CABINET MEMBER FOR ENVIRONMENT – 18 JUNE 2020

OXFORD – OXFORD ROAD, LITTLEMORE – PROPOSED HUMPED ZEBRA CROSSING AND TRAFFIC CALMING MEASURES

Report by Interim Director of Community Operations

Drawing title
Proposed
Humped Zebra Crossing &
Other Features

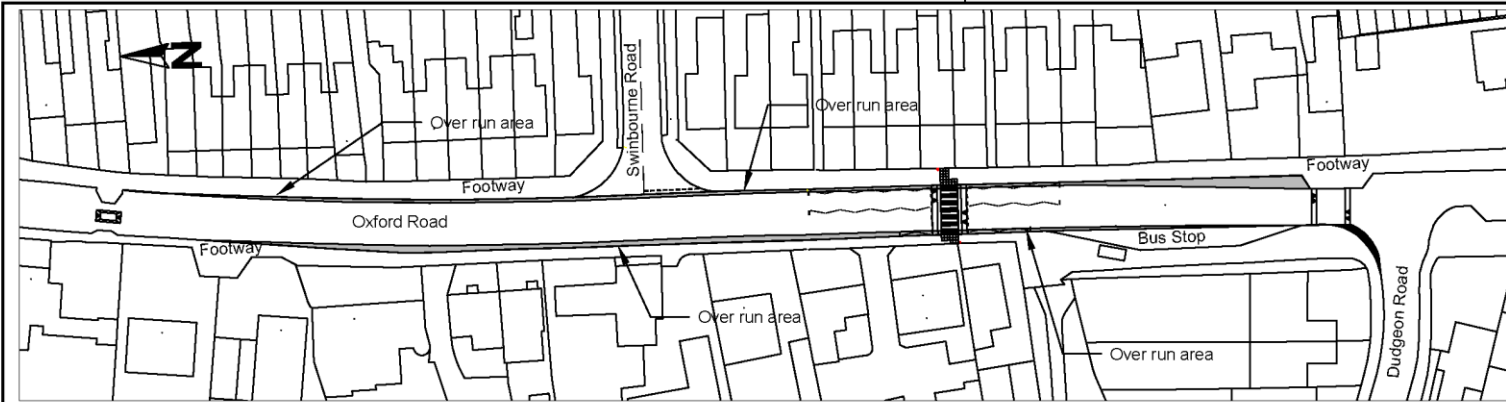
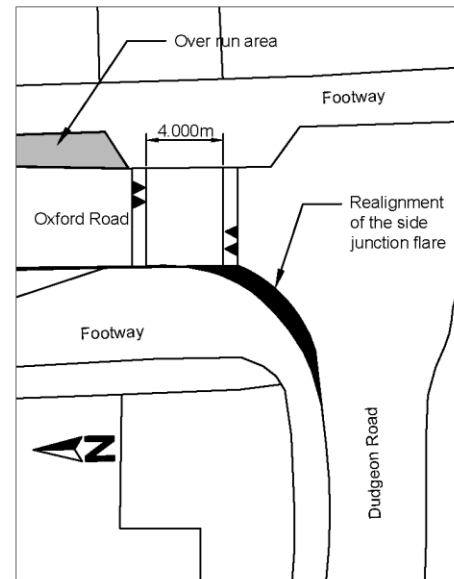
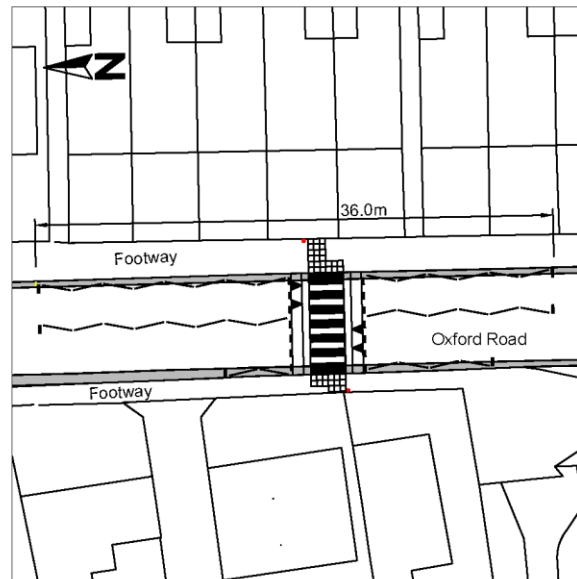
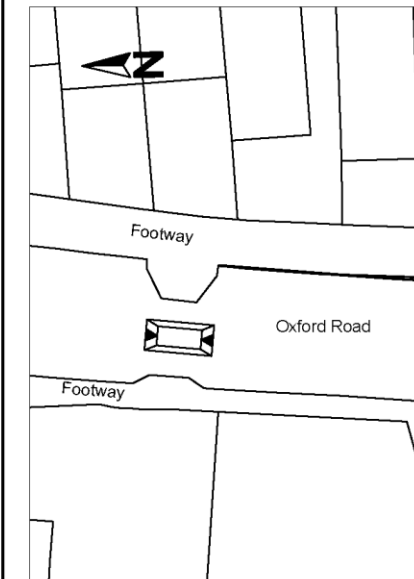
addition of a single speed cushion at chicane 4: objection

My concern about this is that I can't see how it will prevent aggressive drivers continuing to come off the ring road at speed and refusing to give way to north-going drivers, who have the right of way. They justify jumping the give-way sign because the chicane is on a curve in the road (see aerial photo) and it can be difficult to see the traffic you are supposed to give way to. As far as pedestrians are concerned, this is the most dangerous part of Oxford Road: the west side pavement is narrow and bounded by a wall (see photo below). A single central speed cushion might simply force drivers into the middle of the road, making it even more likely that north going traffic will drive on the narrow pavement. The east side pavement is raised, so residents parking here have to load and unload their cars into the road. One lost her rear door while she was lifting her 2 year old out of the car. To my certain knowledge (I saw them all) 3 cars have come off the ring road and overturned as a result of rushing through this chicane: two came to rest near Swinbourne Road, the other spiralled down to hit the wall of the house next to the park entrance. I'm not confident that such risks will be prevented by this measure alone.

addition of a zebra crossing north of the park entrance: objection

The dangers of speeding here are to parked cars, & most residents have had to replace wing mirrors. There have been no recent accidents involving people. The last was 35 years ago when a 5-year old ran out of his front garden into the road and sustained life changing head injuries. He might have been less hurt if there had then been a 20mph limit, but this was not a problem caused by speeding, nor one that could have been prevented by introducing a Zebra crossing. The majority of people who cross the road here are coming to from local schools and home via the park. They cross safely at chicane 3: the proposed zebra will be out of their way. Since many who want the zebra don't wish to go out of their way to chicane 3, it is possible that many who have crossed at the chicane for years won't want to go out of their way either. It risks being a waste of money. Some who want an additional crossing approach the park from the north: there may be sense in having an additional crossing nearer the shop (the original plan was for a third chicane near the shop), but a zebra crossing here is not necessary. It would deprive about 9 households of parking space, though there is already insufficient space for all residents, and there are no side roads which residents might use as alternatives (Dudgeon Drive is full, Blewitt Court is private land, and Swinbourne Road is for residents only). Swinbourne residents already complain that Oxford Road residents flout this because there isn't room in the north end of Oxford Road, and because it isn't safe to park on Oxford Road.

addition of a speed bump across the road at Chicane 3: objection

I have a particular interest in this as I live beside this chicane: the main problem here it is that its design is ambiguous: a sign tells north-going traffic to give way to oncoming vehicles, but the road is wide enough for cars to pass, and there is a dotted white line through it (see photo). It has to carry exactly the same sort of traffic as the 3 other chicanes between the Littlemore Hospital and the ring road, but the road is more than 1 metre wider at this chicane than at the other 3. So north-going traffic which has been calmed by the 2 chicanes near the railway bridge speeds up to go through this one, even though south-going traffic has right of way. The result is a lot of noise: swearing, and prolonged horn blowing by south going traffic. The proposal solely to add a speed bump will do nothing to address these issues and might simply add to the disturbance in my home.

addition of white zig-zag lines: neither for nor against

I don't understand how they are expected to work. Much of the severe speeding is at night when they will be obscured by parked cars.

11. Given the lack of reported injury-accidents and in the light of the high level and strong tone of objections it is recommended to withdraw the current proposals but to investigate alternative calming. The road width and local geography precludes speed cushions but consideration will be given to all calming suggestions made during consultation.
